| project                             | drawing                       | date          |
|-------------------------------------|-------------------------------|---------------|
| PLOT 4 LLYS BARAN, RHYDYFRO S48 4RW | FLOOR PLANS & ELEVATIONS      | DECEMBER 2021 |
| MR MARTIN EVANS                     | 21.LBR.06a                    | 1   50 @ A1   |

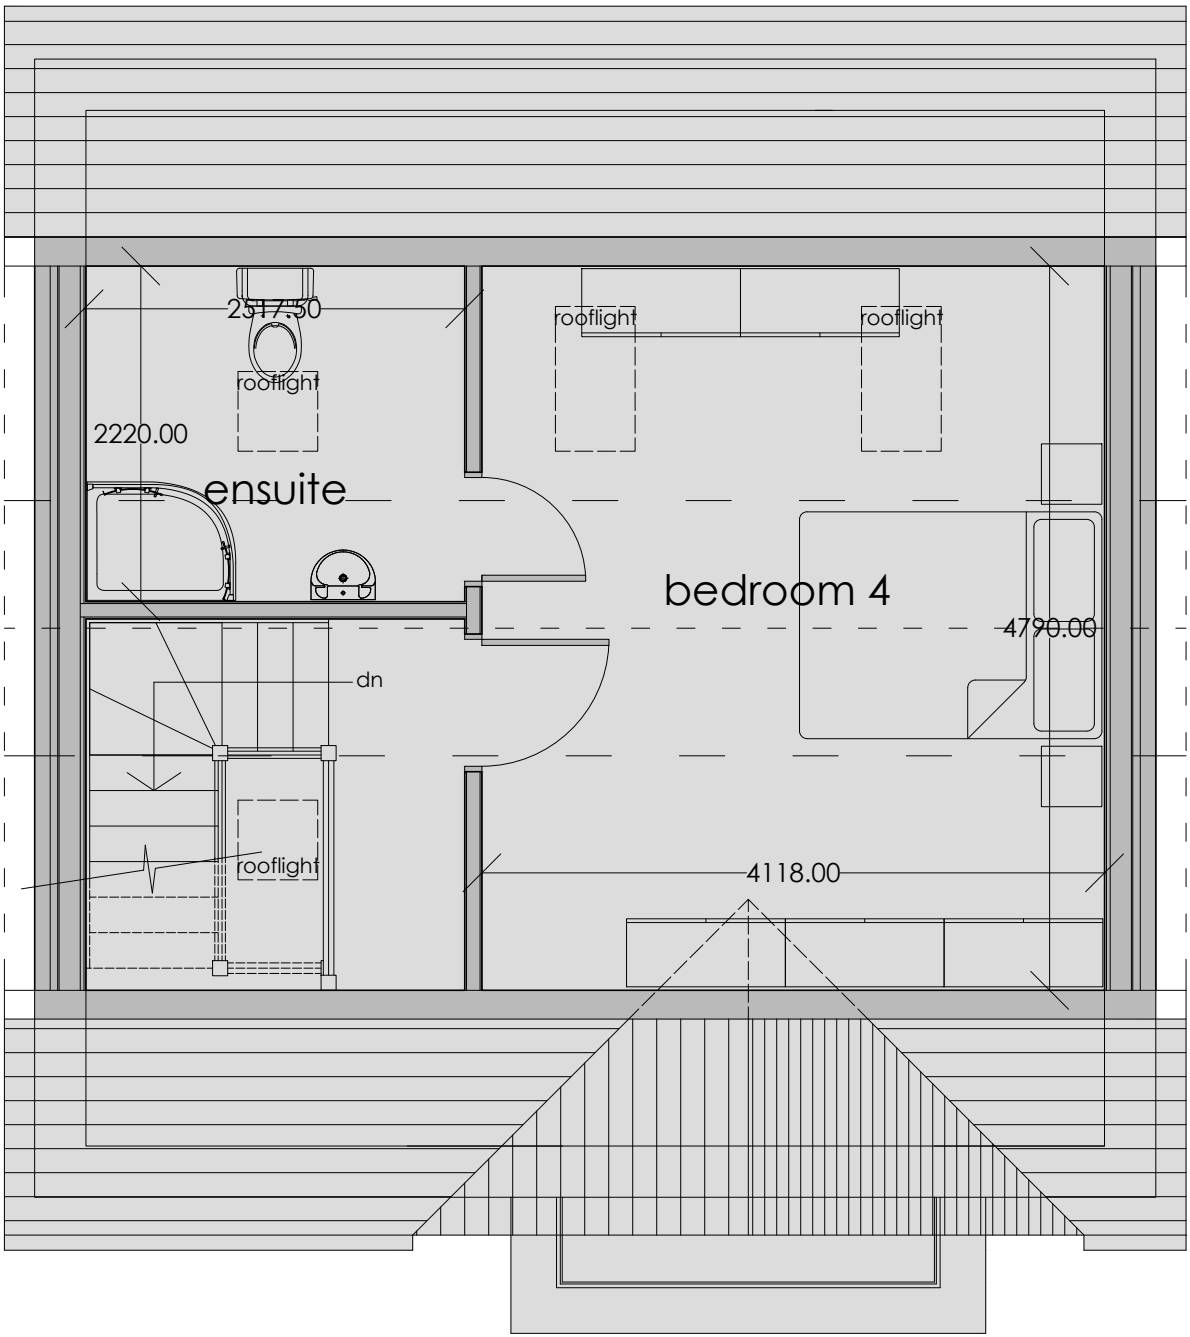
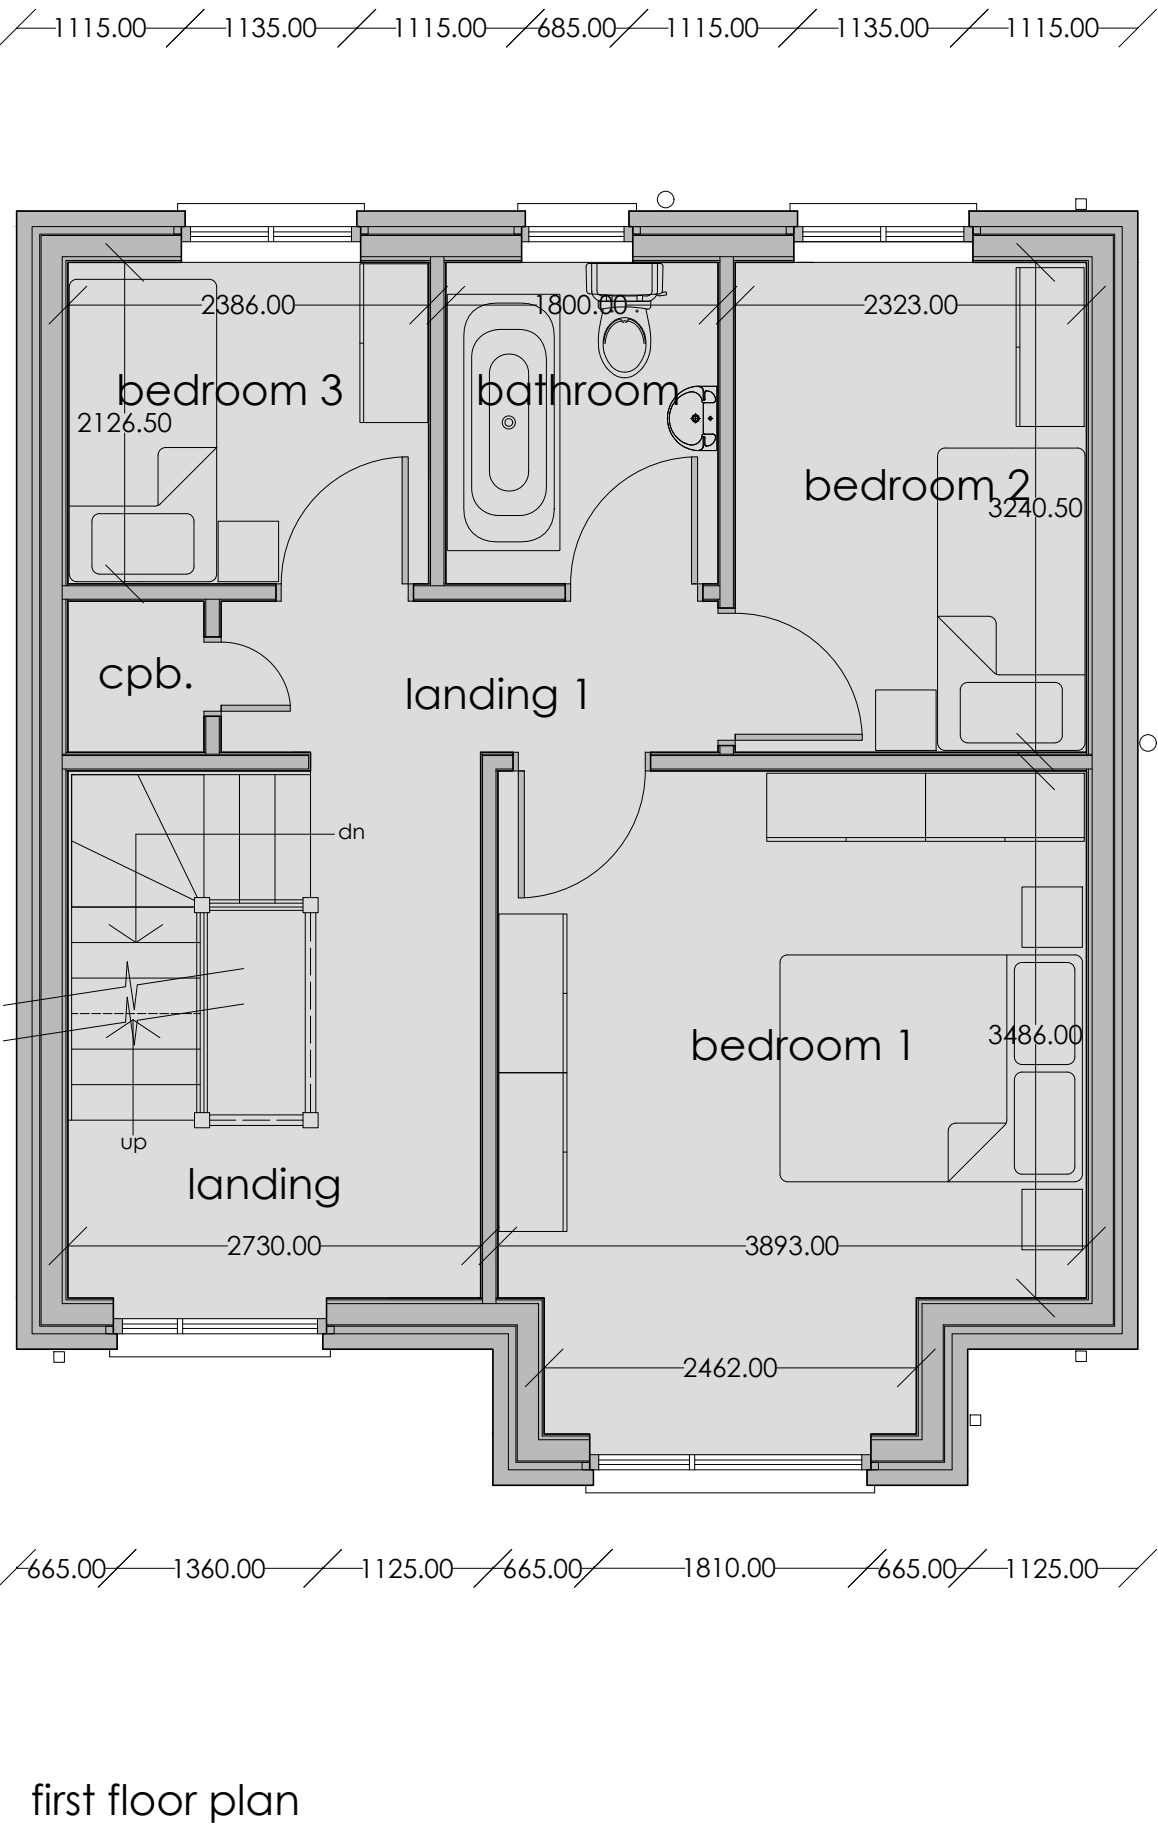
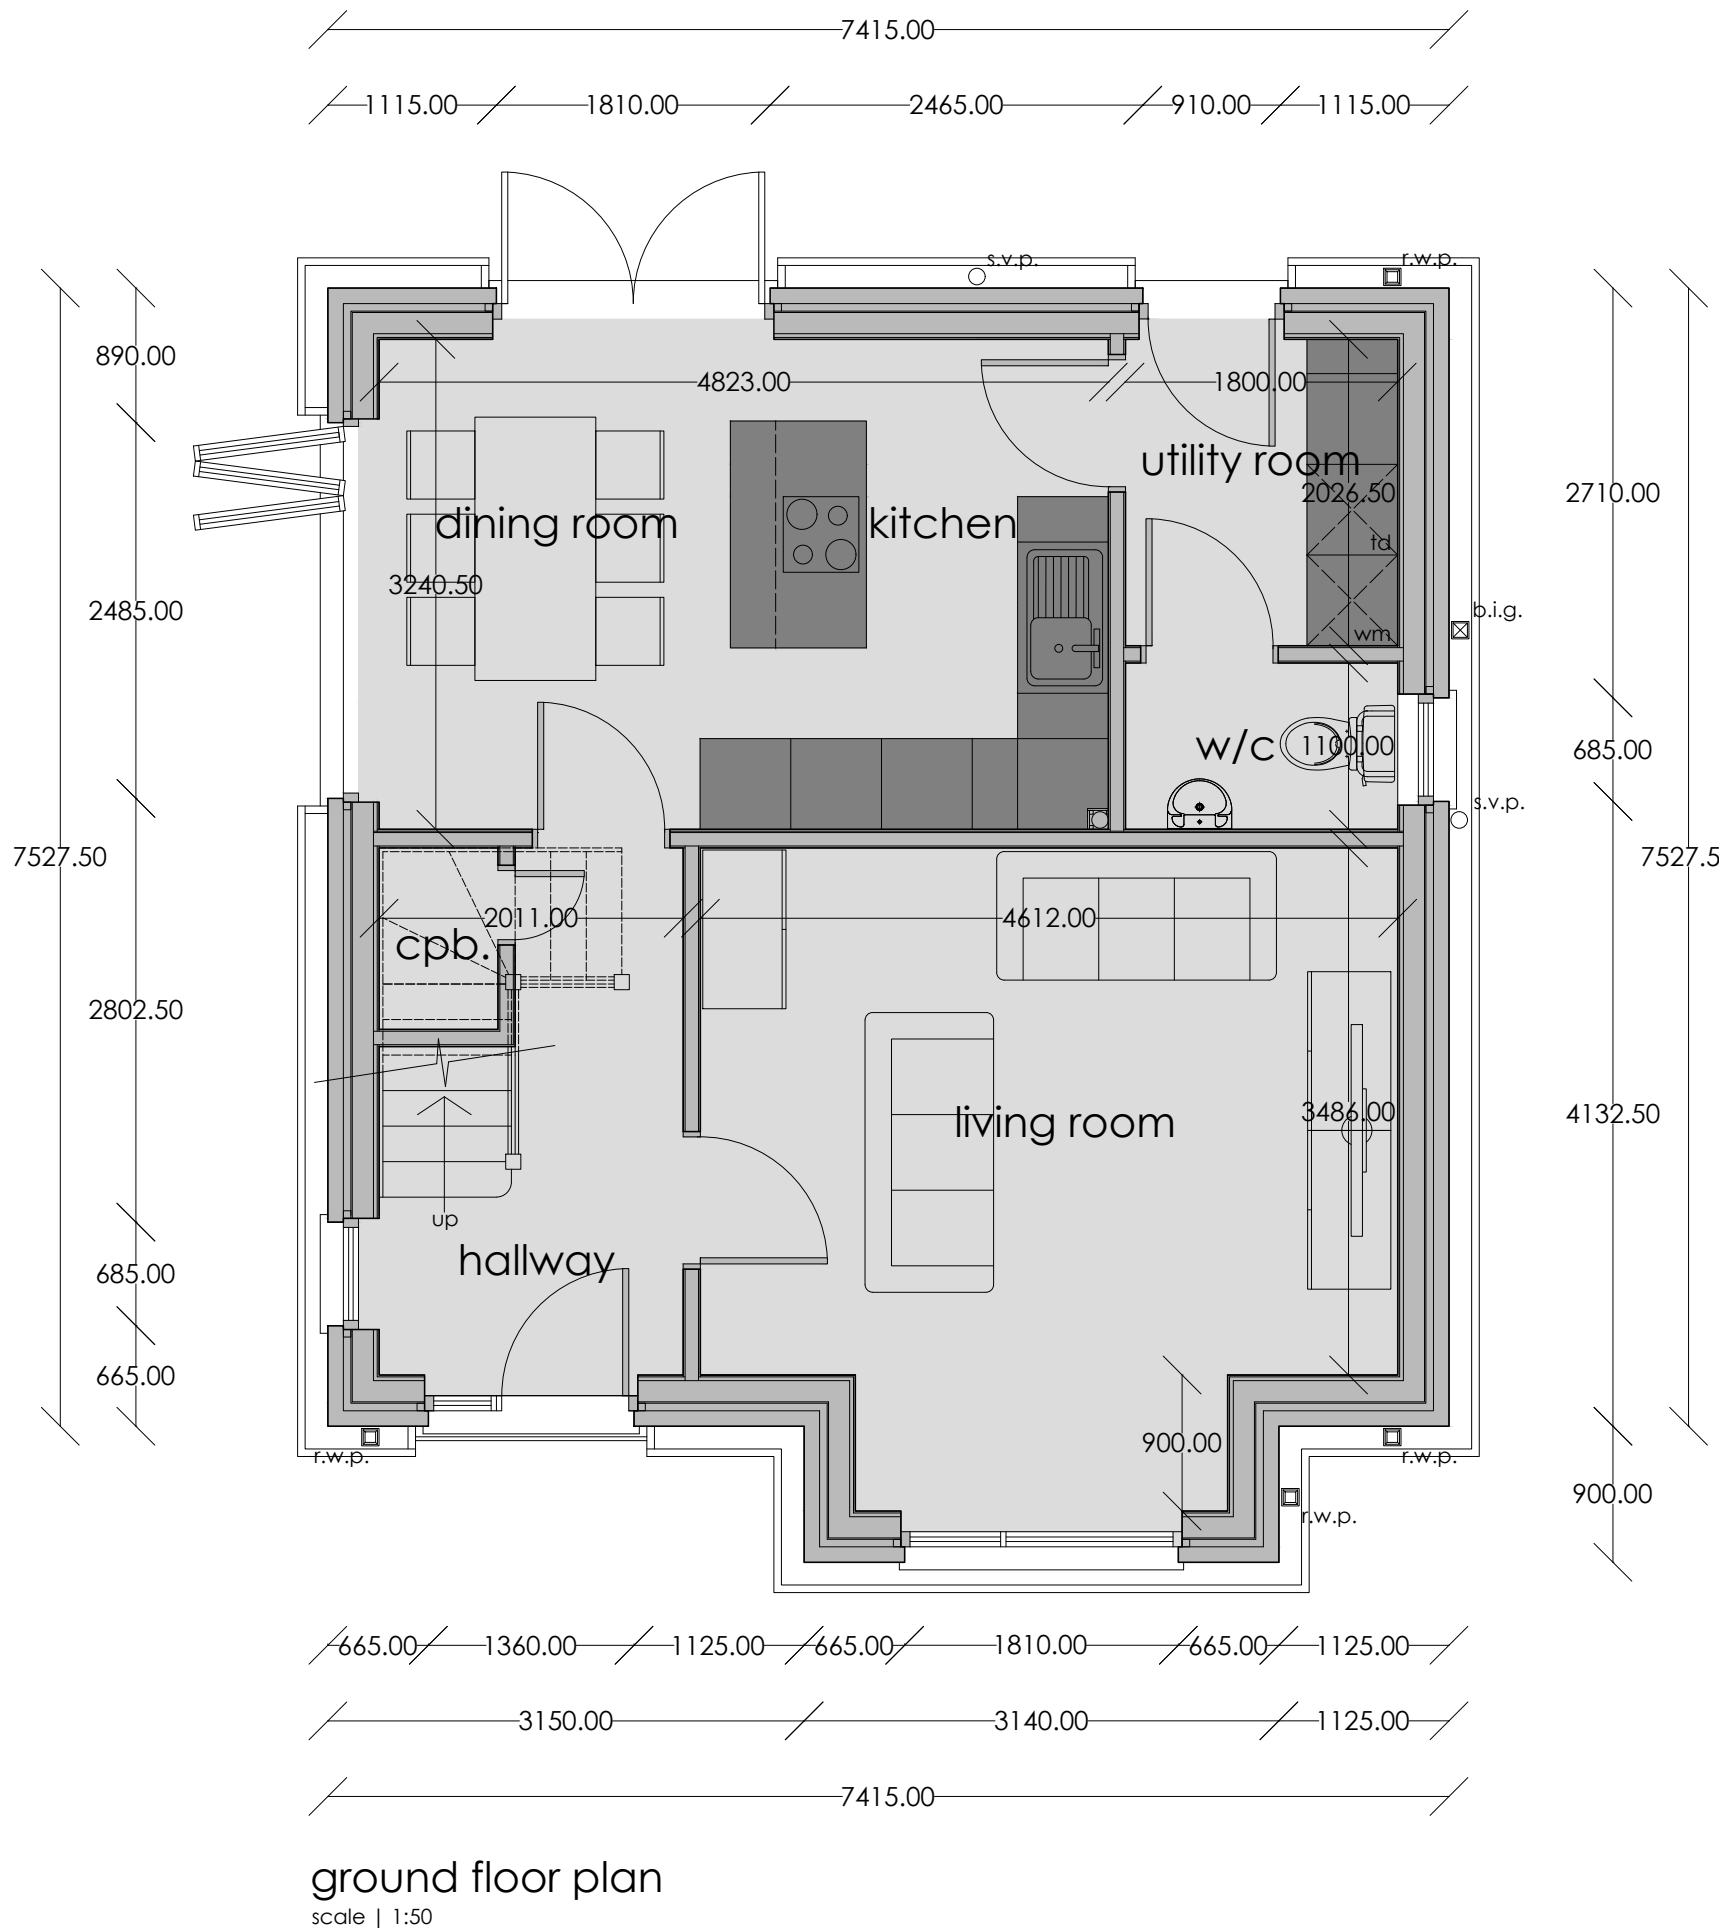
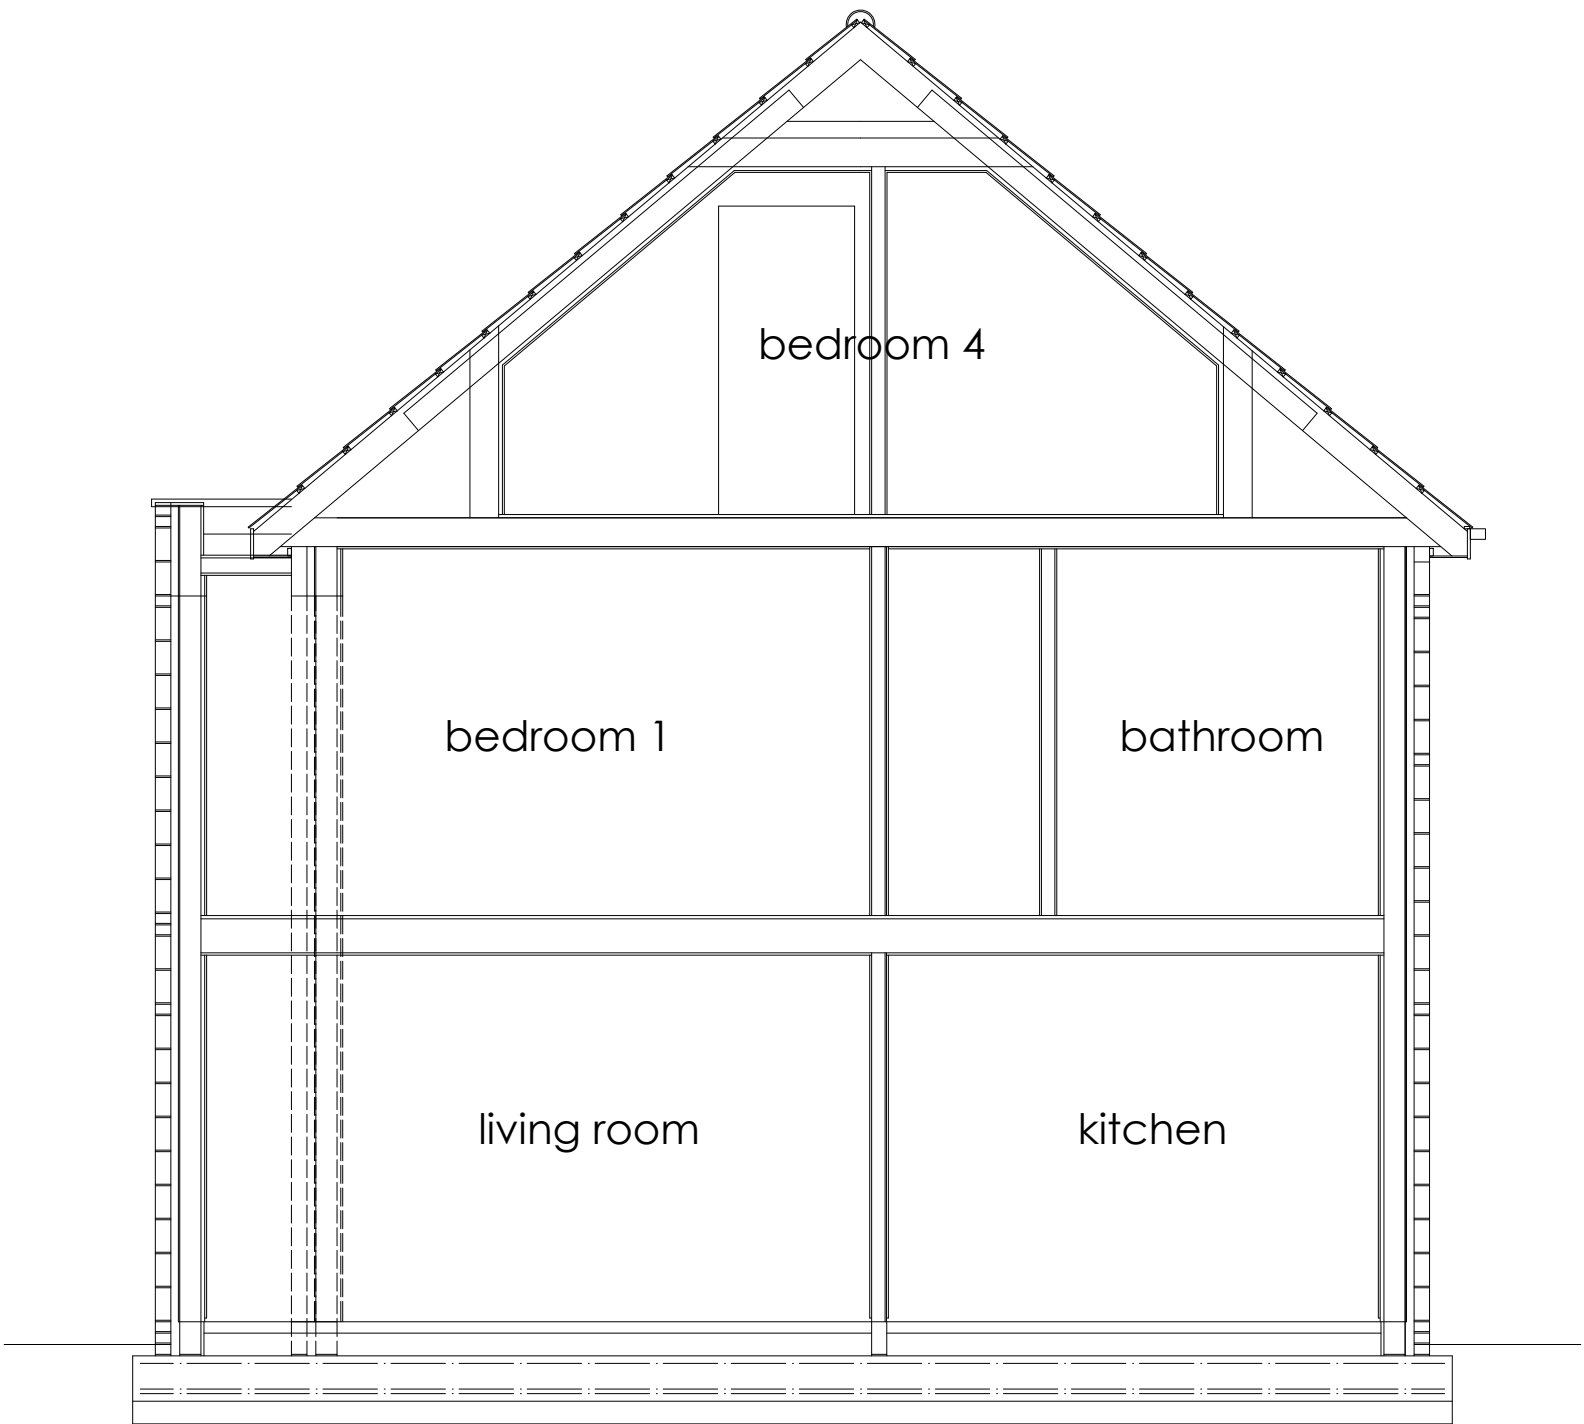
| revision |                                                                                                  |
|----------|--------------------------------------------------------------------------------------------------|
| a        | bio-diversity enhancements added (bat box) to north elevation at the request of the lpa_08.08.22 |
